<b>STAFF REPORT</b>	
<b>COMMUNITY DEVELOPMENT DEPARTMENT</b>

HEARING DATE: October 20, 2022  
 (Continued from: August 18, and Sept. 1 and 15, 2022)  
 TO: Planning & Zoning Commission  
 FROM: Sonya Allen, Associate Planner  
 208-884-5533  
 SUBJECT: Kingstown  
 H-2022-0045  
 LOCATION: 2610 E. Jasmine St., generally located in the south 1/2 of Section 32, T.4N., R.1E. (Parcel #R4582530400)

Annexation of 8.20 acres of land with an R-8 zoning district; and preliminary plat consisting of 28 building lots and 6 common lots on 8.20 acres of land in the R-8 zoning district for Kingstown Subdivision.

## Updated Conceptual Plat & Neighboring Parcels Exhibit:

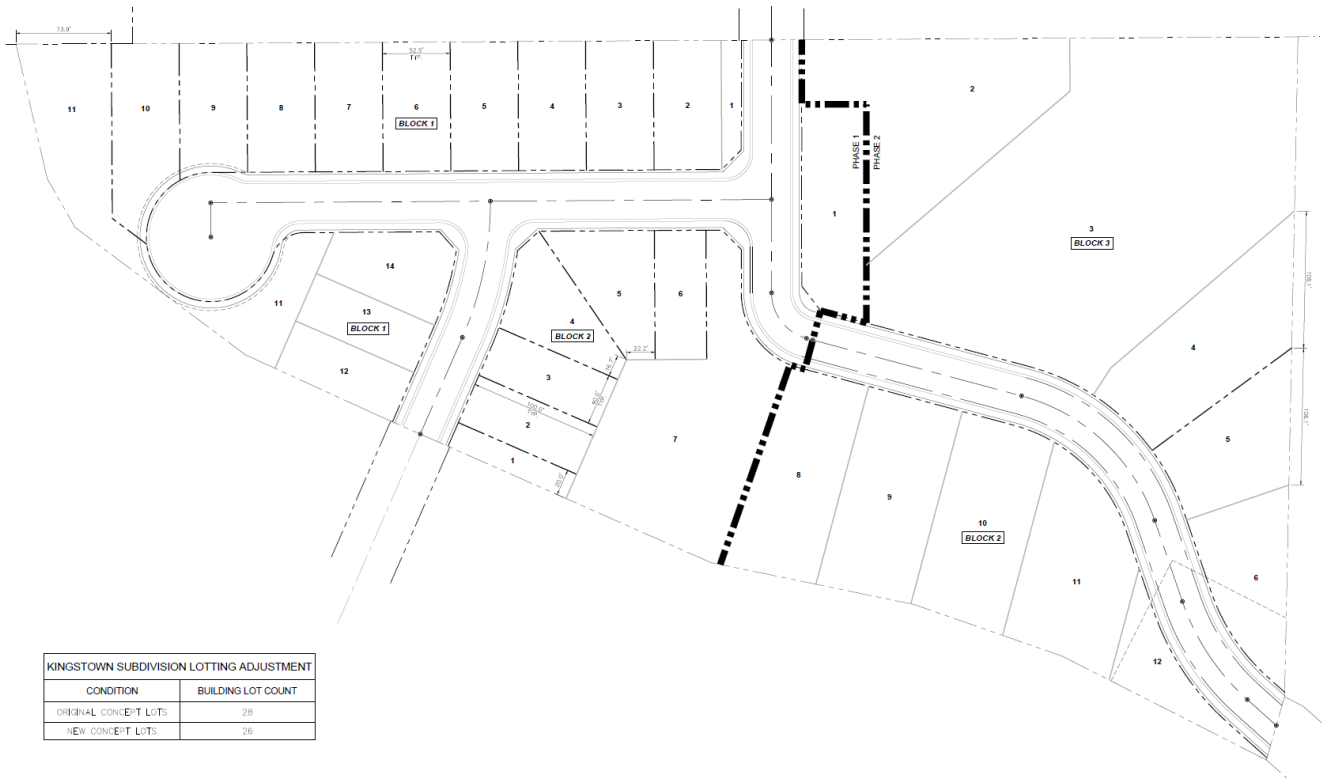
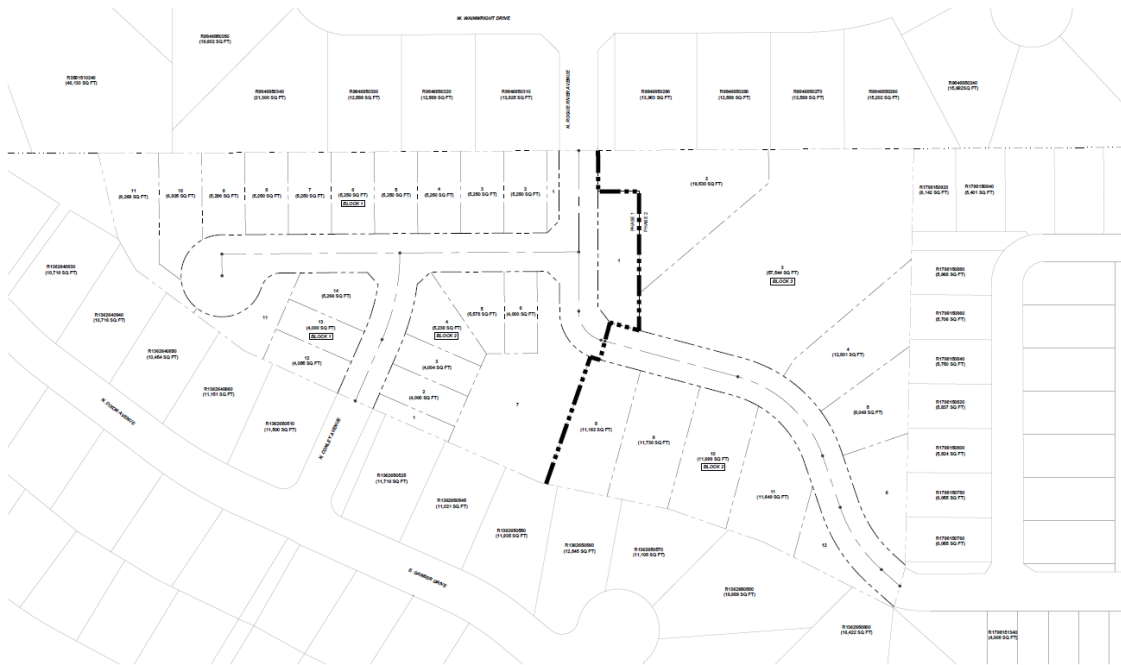
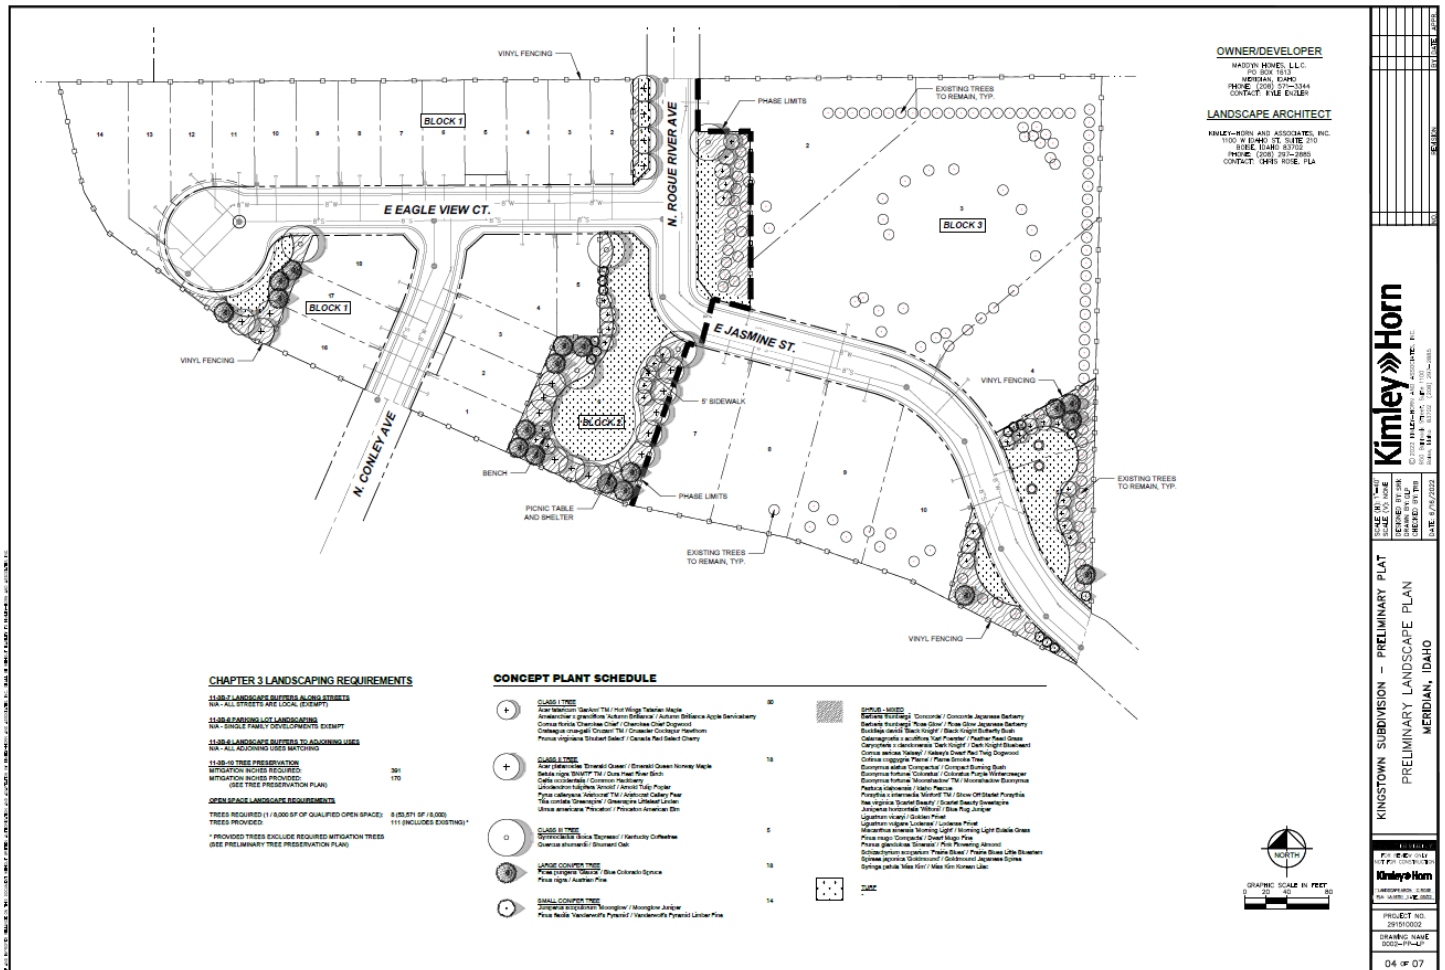
***At the recommendation of Staff, a revised conceptual plat was submitted that depicts a reconfiguration of lots within the plat resulting in a reduction in building lots from 28 to 26 and an increase in common lots from 6 to 7 for a gross density of 3.17 units/acre (see Section VIII.B). If the Commission recommends approval of the revised concept plan, an updated plat, landscape plan and open space exhibit should be submitted at least 10 days prior to the Council meeting and the staff report will be updated accordingly.***

**City Engineer's signature on the final plat.** *Note: The Applicant submitted a revised conceptual plat that includes the 20-foot wide common lot for a pathway as recommended by Staff.*

**EXISTING TREE PLAN**

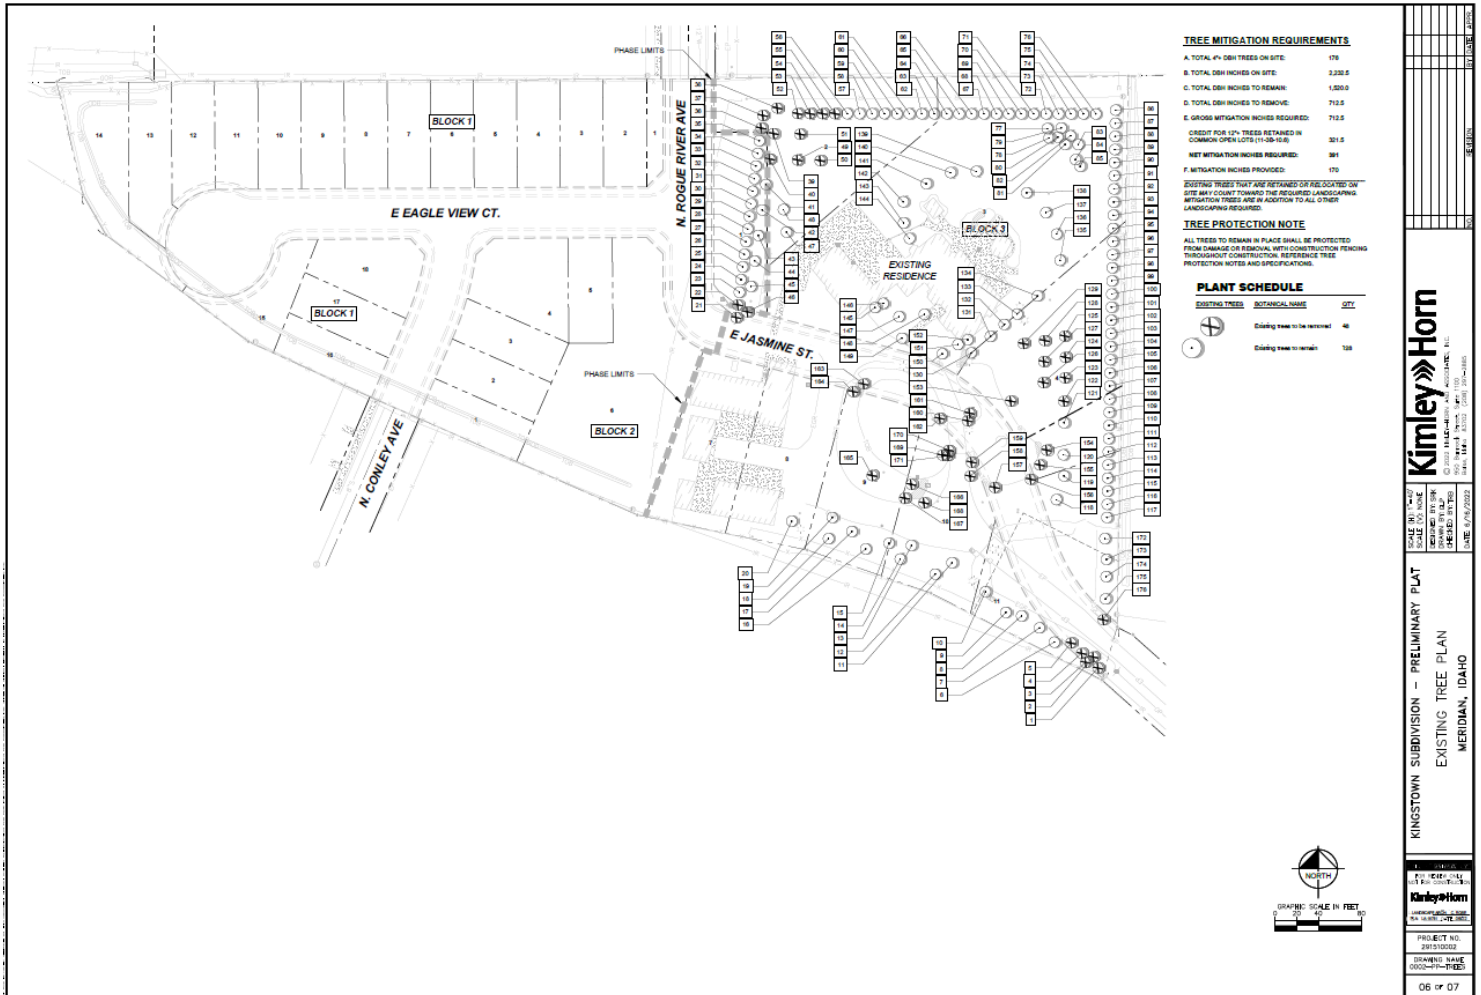
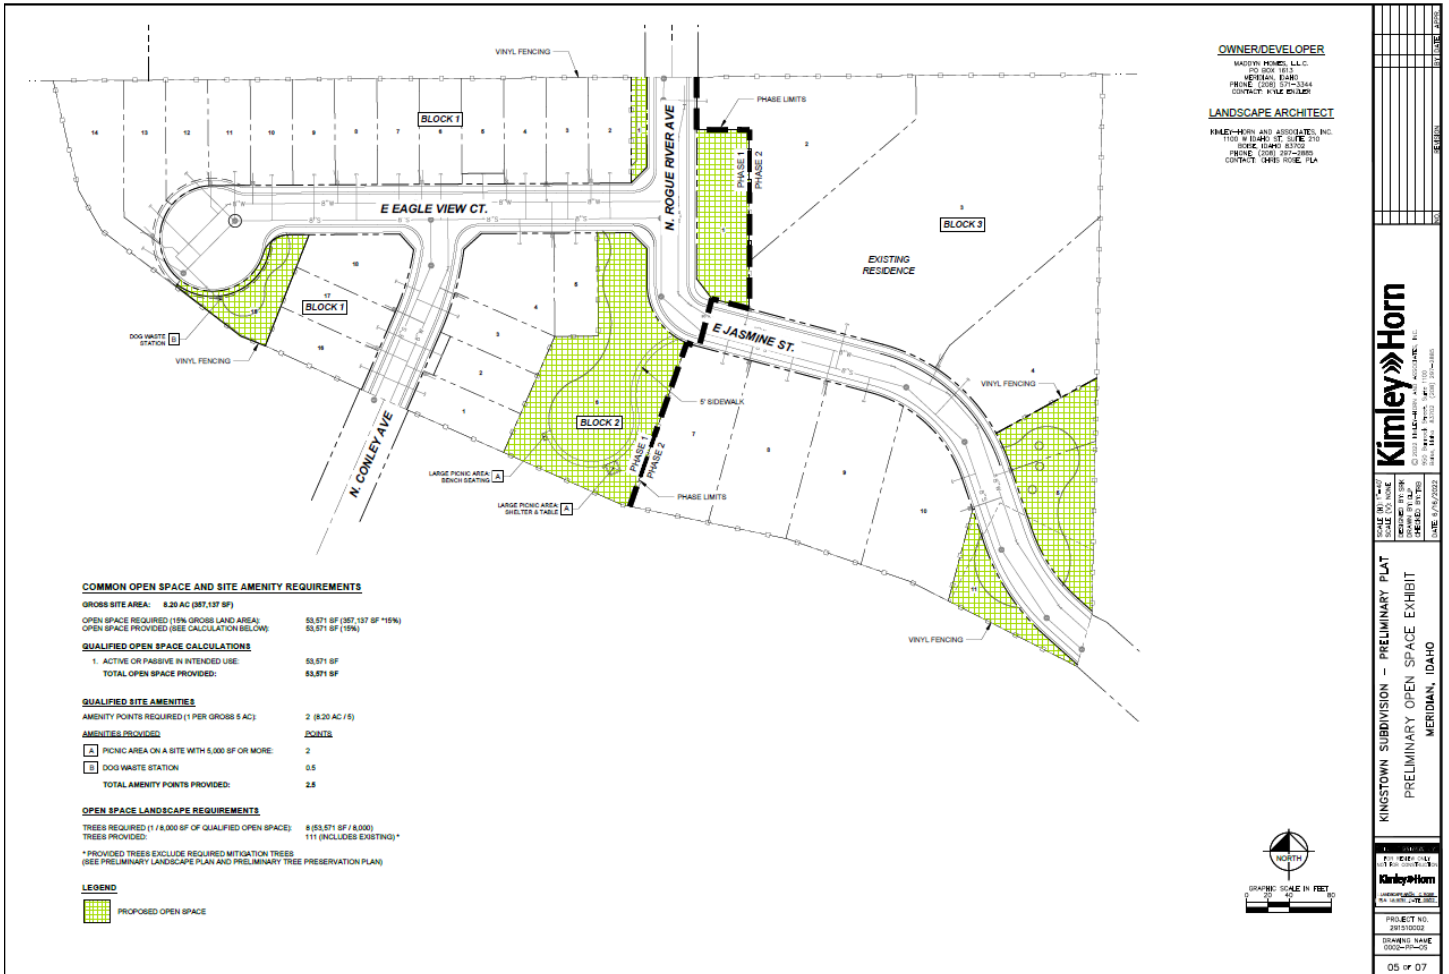
There is a total of 176 existing trees on the site totaling 2,232.5 caliper inches (see existing tree inventory and plan in Section VIII.D). A total of 1,520 caliper inches are proposed to remain with 712.5 caliper inches proposed to be removed. **A total of 391 caliper inches are required for mitigation as set forth in UDC [11-3B-10C.5](#); a total of 170 is provided, which is 221 less than required. Staff recommends one (1) 2-inch caliper tree is provided in the front and back yards of each building lot toward the mitigation requirement, which would leave 109 caliper inches remaining that could be provided in common lots, or Alternative Compliance could be requested to this standard for the remaining mitigation trees (see UDC 11-5B-5 for more information).**

- b. Provide one (1) 2-inch tree in the front and back yards of all building lots and an additional 109 caliper inches of trees on the site in common areas in accord with the mitigation standards listed

in UDC [11-3B-10C.5](#); or, apply for Alternative Compliance to this standard (see UDC 11-5B-5 for more information).
